NOTICE OF DECISION

PLANNING ADMINISTRATOR DECISION FOR MODIFICATION OF TENTATIVE PHASED SUBDIVISION PLAN

CASE NO.: FRP-PAR-SUB14-01MOD1
AMANDA NO.: 21-112013-LD
DATE OF DECISION: December 22, 2021
PROPERTY LOCATION: 2250 Strong Road SE
APPLICANT: Eric Olsen (Olsen Design and Development)

Original Approved Subdivision Phasing Plan

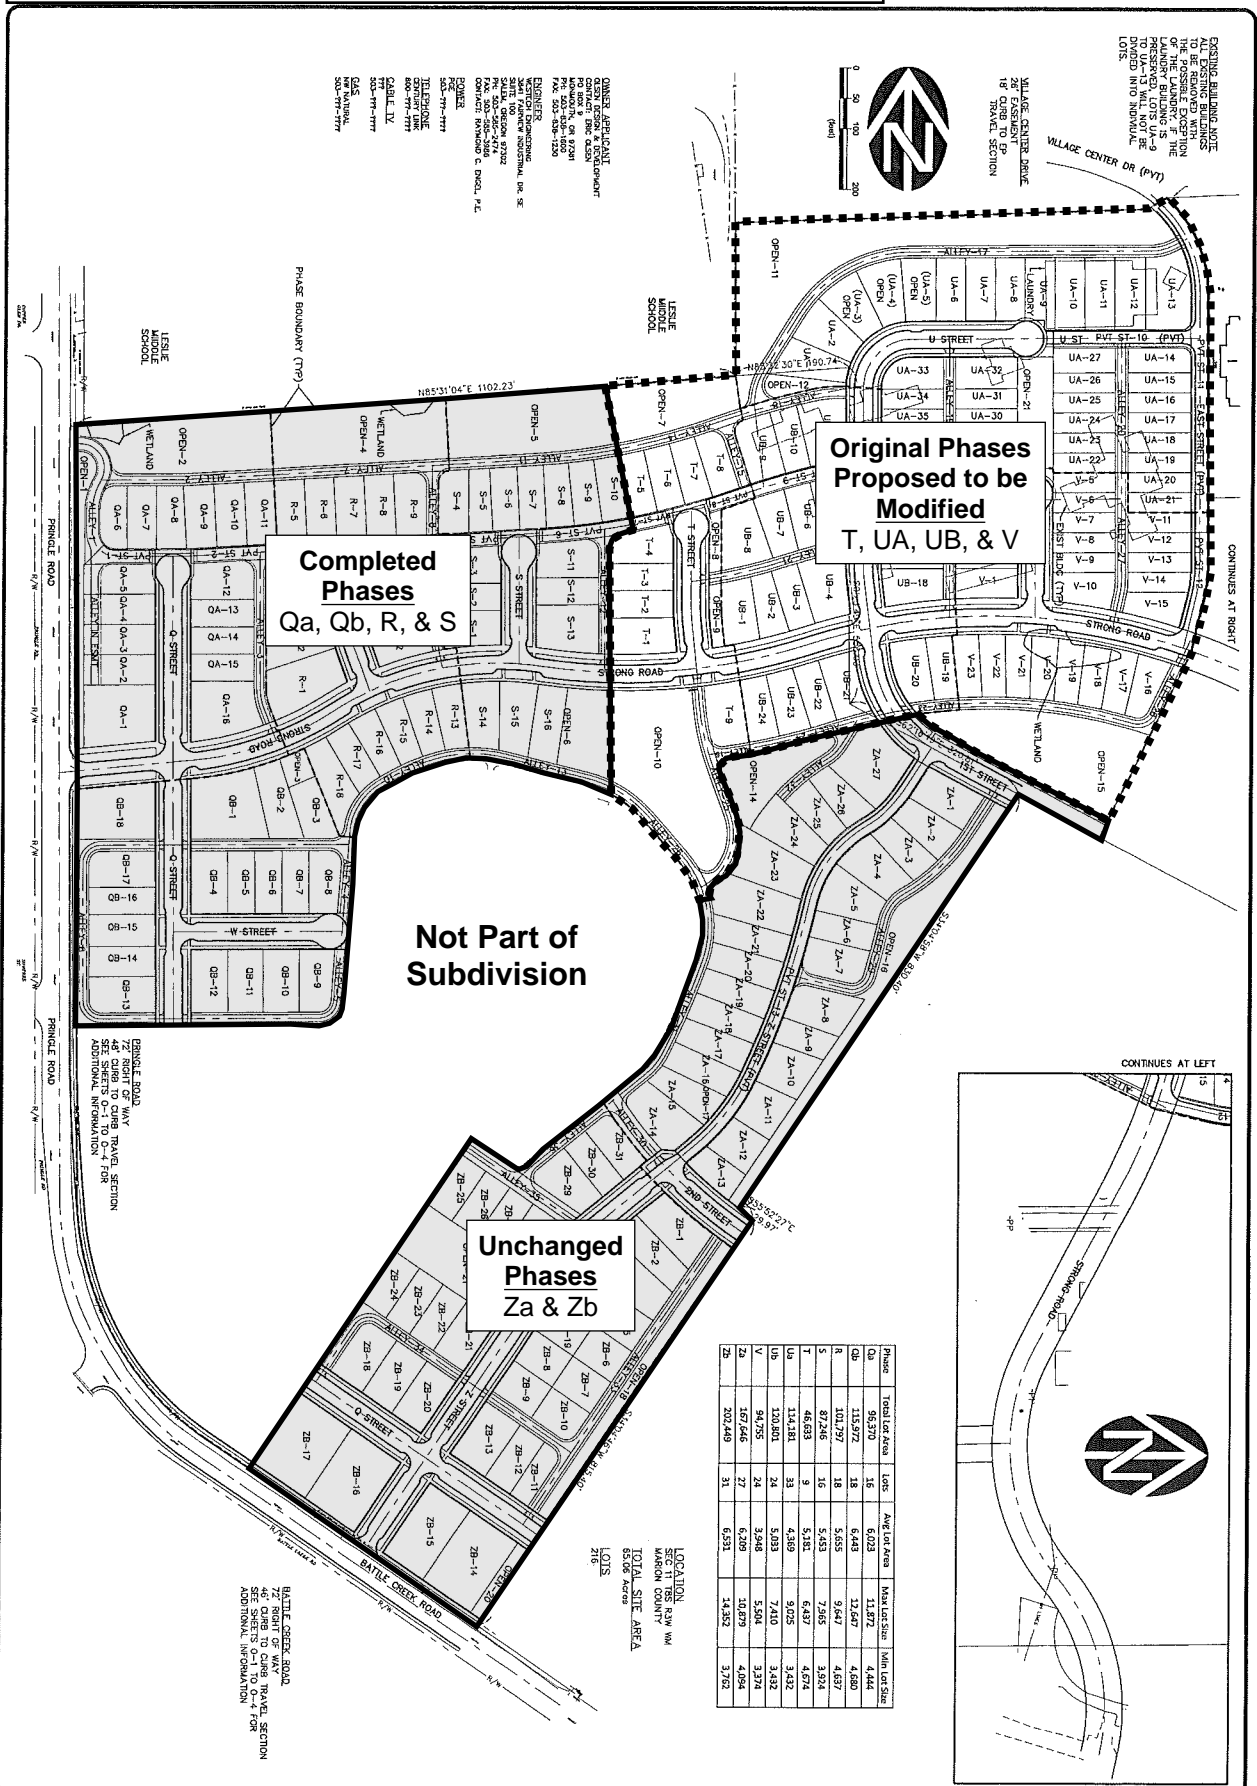
**Original Phases Proposed to be Modified
T, UA, UB, & V**

Modified Subdivision Phasing Plan

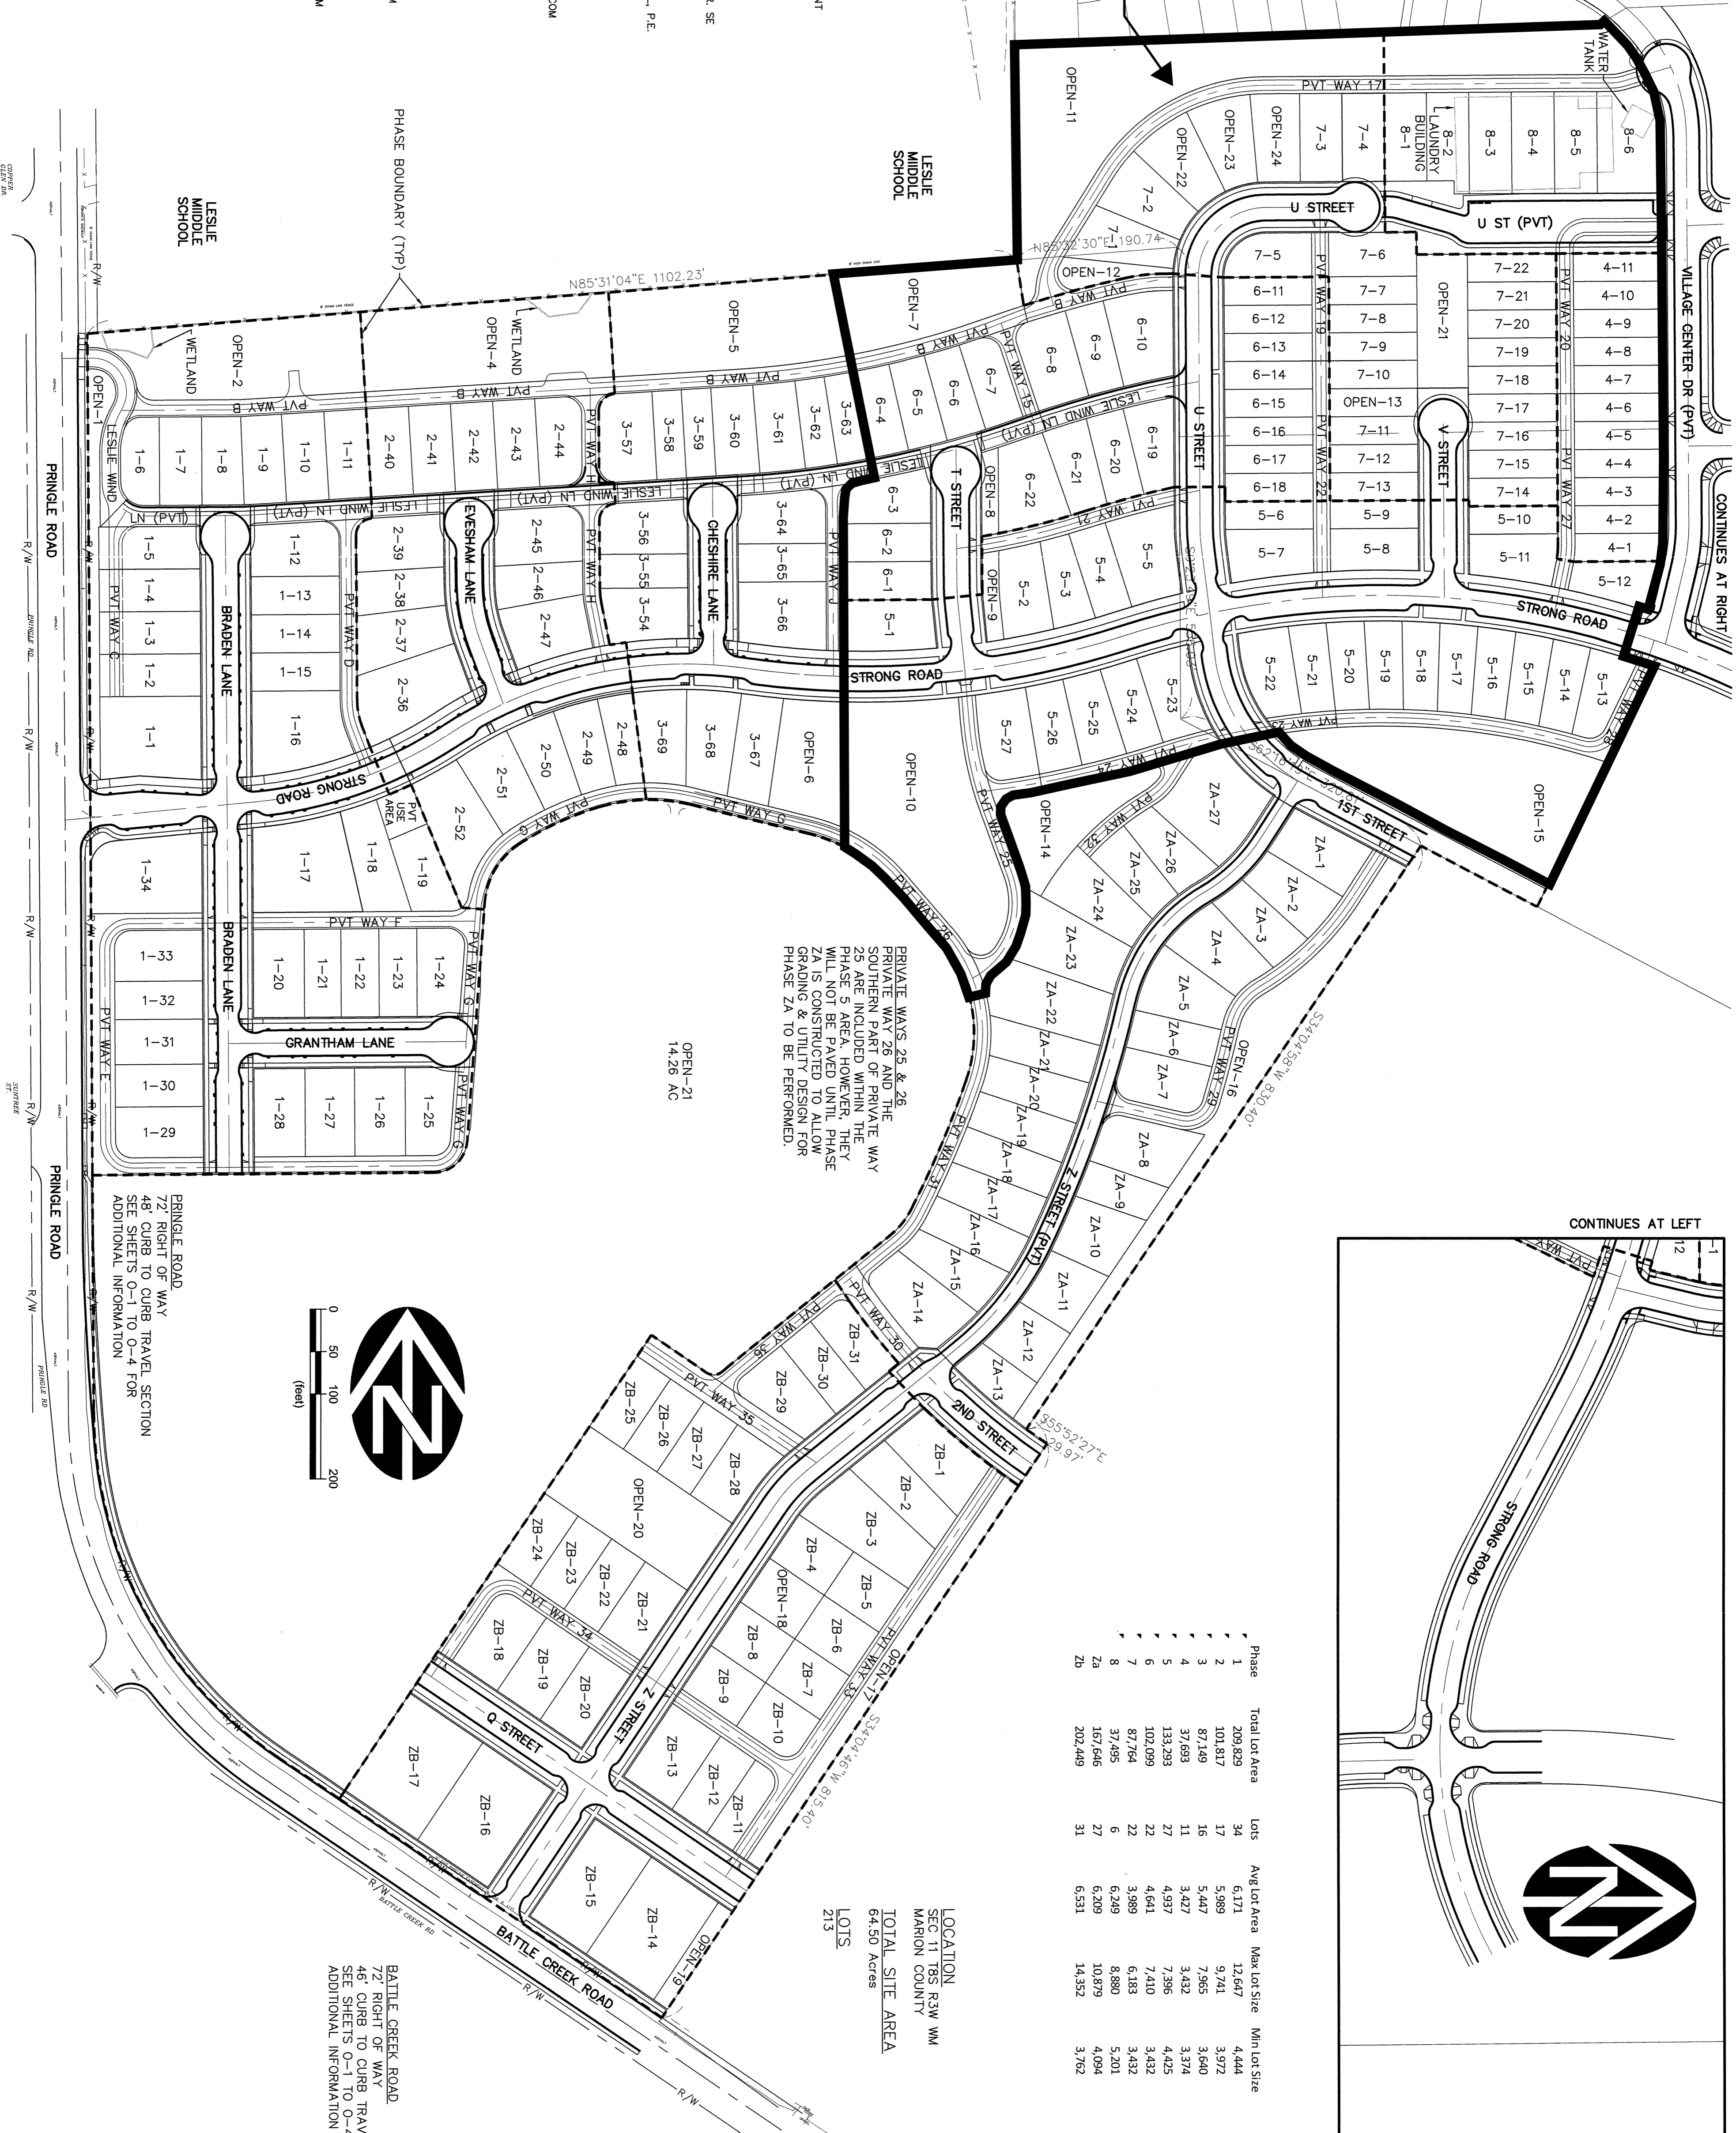
The modified tentative phased subdivision plan relocates the boundaries of phases T, Ua, Ub, and V, establishes a new fifth phase in the modified area, and renumbers the phases as phases 4, 5, 6, 7, and 8.

The modified tentative phased subdivision plan proposes a minor modification to the alignment and design of U Street adjacent to the former laundry building in order to facilitate the potential redevelopment of the existing building and provide additional on-street parking. Under the proposed modification, the cul-de-sac turnaround at the end of the public portion of U Street is relocated to the west and the alignment of the private section of U Street is shifted slightly to the south. As a result of the proposed changes, the cul-de-sac and the realigned private section of U Street will be located in closer proximity to existing trees that are identified for preservation under the approve tree conservation plan.

In order to facilitate the redevelopment of the former laundry building and provide additional on-street parking, the proposed modified tentative subdivision plan increases the width of U Street adjacent the laundry building. As shown on the modified tentative phased subdivision plan and the proposed modified street cross section drawings for the street (**Attachment E**), the section of U Street within Phase 8 is private and comprised of two sections, a U Street driveway section and a U Street parking section. The U Street driveway section consists of a 24-foot-wide travel land and sidewalks on both sides of the street. The U Street parking section consists of a 24-foot travel lane, 90-degree perpendicular parking on the north side of the street, parallel parking on the south side of the street, sidewalks on both sides of the street, and a planter strip on the south side of the street.

- a. If the laundry building is retained and redeveloped, the private section of U Street shall be constructed as shown on the modified tentative phased subdivision plan and the modified street cross section drawings. The U Street driveway section of the street shall include street trees along both sides of the street.
- b. If the laundry building is removed and not redeveloped, the private section of U Street shall either be:

Condition 20: Vehicular access to the private alley serving the lots in Phase 4 shall be provided by a temporary driveway within Phase 8 as shown on the modified tentative phase subdivision plan and the modified street cross section drawings.

TEMPORARY D/W TYPICAL SECTION (PHASE 4)
(FOR PVT WAY 20 ACCESS)

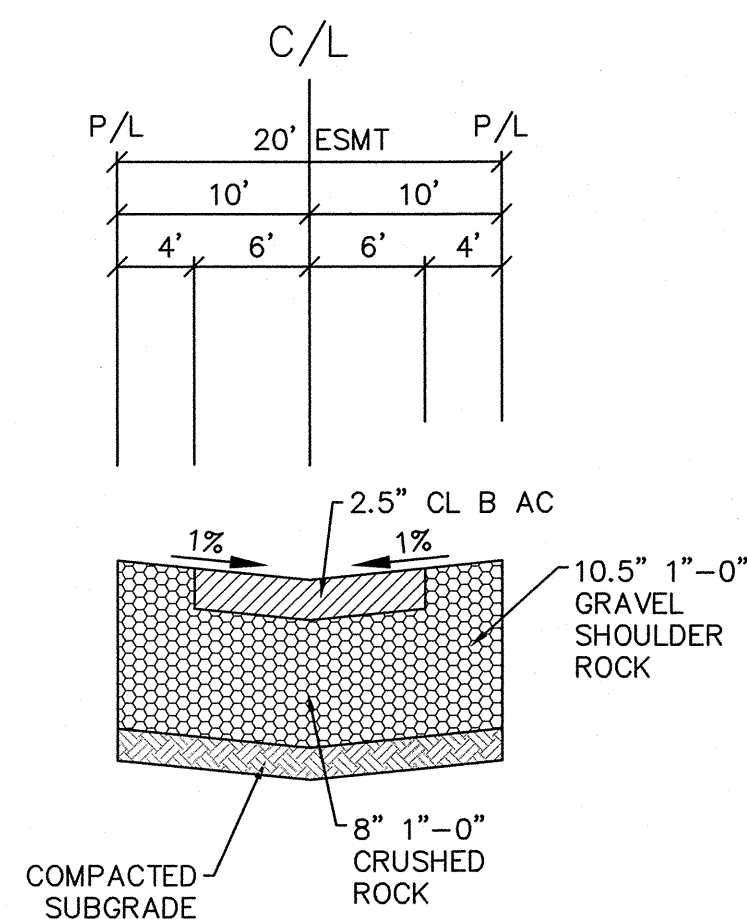
As shown on the proposed modified tentative phased subdivision plan, lots within Phase 4 have frontage on Village Center drive SE and will be served by a private alley at the rear of the lots. Based on the modified subdivision phase boundaries, vehicular access to the private alley at the rear of the lots in Phase 4 is proposed to be taken from a temporary driveway located in Phase 8 until Phases 5 and 8 of the subdivision are completed. In order to ensure vehicular access to the alley serving the lots in Phase 4, the following condition of approval shall apply:

PRIVATE STREET U DRIVEWAY AREA (PHASE 8)
TYPICAL SECTION

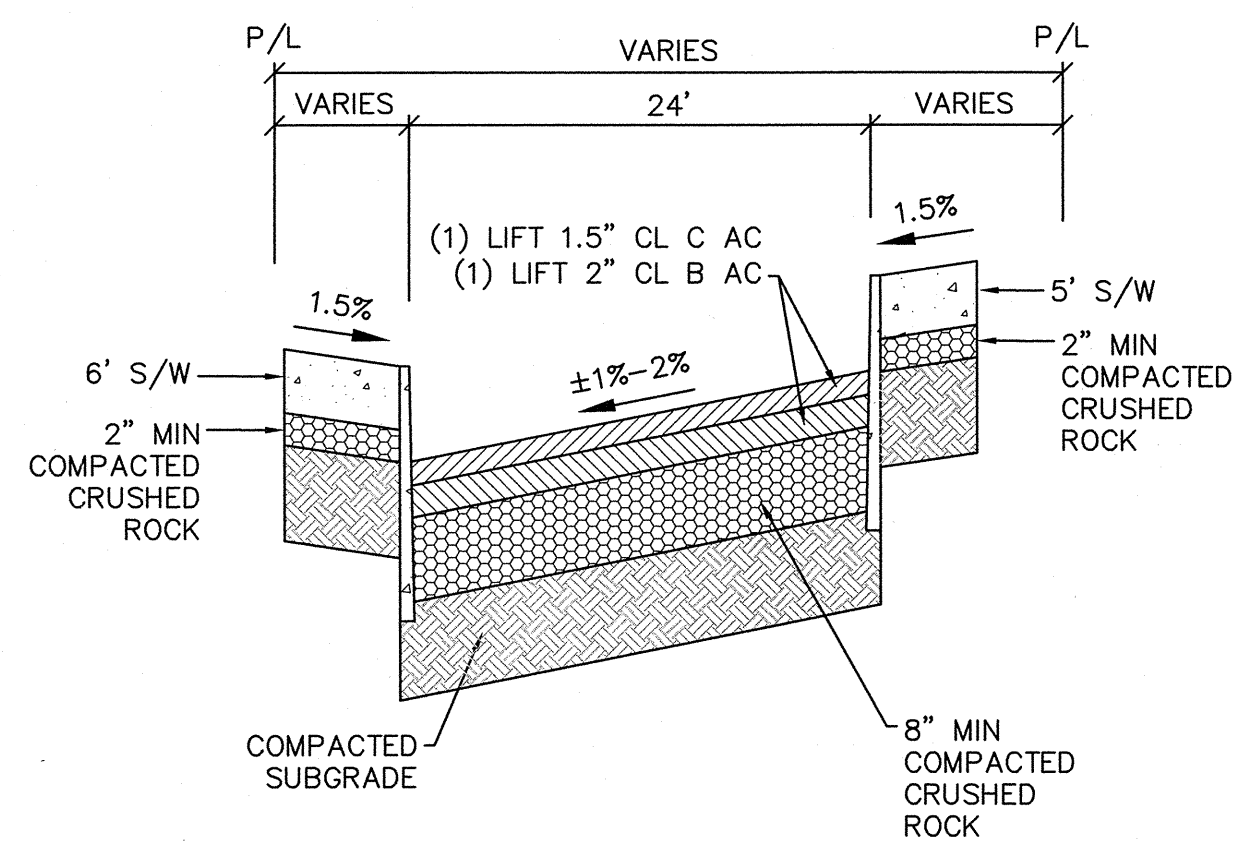
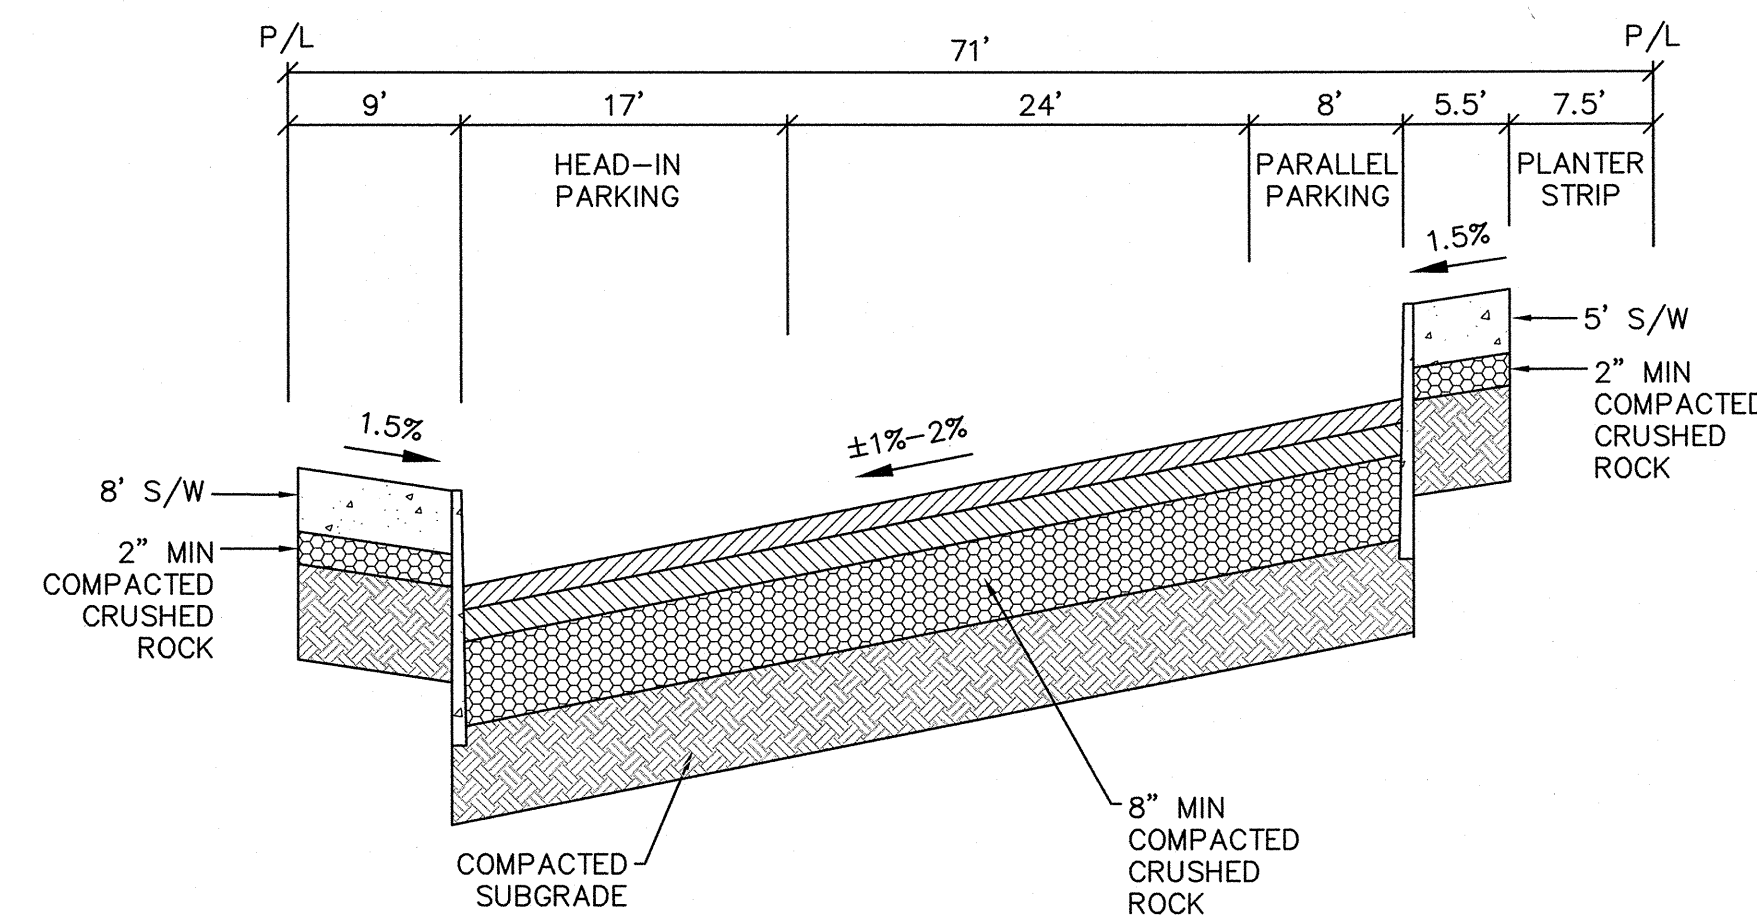
Because the proposed modified design of the private section of U Street is only necessary in connection with the redevelopment of the laundry building and the additional street width provided for on-street perpendicular parking is not necessary if the laundry building is not redeveloped and Phase 8 is instead platted as individual lots, the following condition of approval shall apply to the design of the private section of U Street to ensure that the street improvements are consistent with the ultimate development of the laundry building site:
